### **ADDENDUM NO. 1**

TO: All Prospective Bidders  
DATE: April 7, 2016  
PROJECT: Music Department Interior Improvements  
(WP-16-02-01)

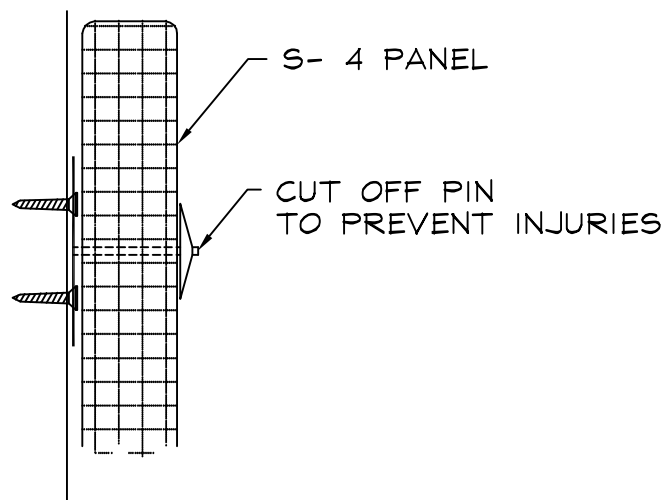
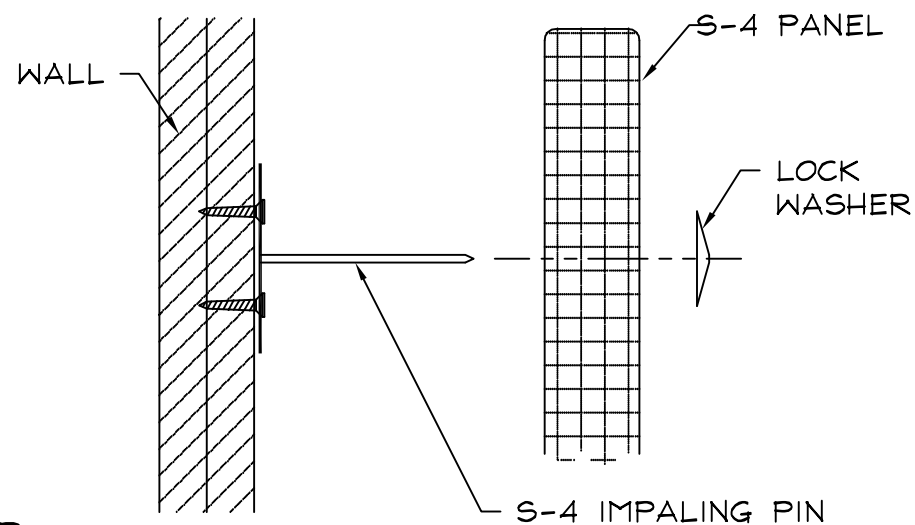
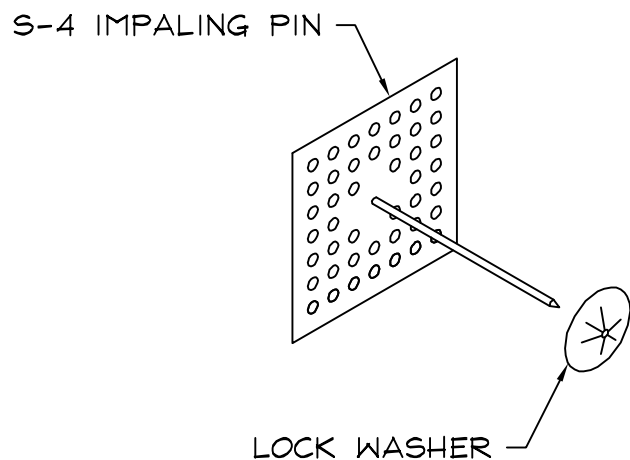
1. Acoustical Panel Mounting Hardware: For the installation of the Kinetics Acoustical Panels, use the KineticsS-4 Impaling Pin method as per attached Kinetics Drawing INSTAL15 or similar approved tamperproof method.

1. DETERMINE EXACT PANEL LOCATIONS
2. FASTEN IMPALING PINS TO WALL WITH SCREWS OR CONSTRUCTION ADHESIVE
3. IMPALE PANEL ONTO PINS
4. CUT OFF EXCESS PIN LENGTH

PANEL LENGTH	# OF CLIPS
UP TO 24"	4
24" TO 48"	4
48" TO 72"	4 - 6
72" TO 96"	6 - 8

NOTE: CONSTRUCTION ADHESIVE MAY BE USED IN ADDITION IF DESIRED
